Product Change Notification

Change Notification #: 119788-00

Change Title: Intel® RealSense™ Depth Camera D457,
PCN 119788-00, Product Material,
FAKRA connector change from C-code to Z-code

Date of Publication: January 17, 2024

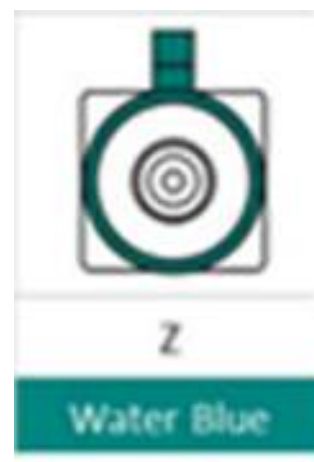
The FAKRA connector in the Intel® RealSense™ Depth Camera D457 is changed from C-code to Z-code

Current FAKRA Connector: C-Code

New FAKRA Connector: Z-Code

No impact is expected to customers, as Z-code connector is compatible with all FAKRA connectors. The camera's rear house design will be modified to accommodate the new connector, but the camera's dimensions remain the same.
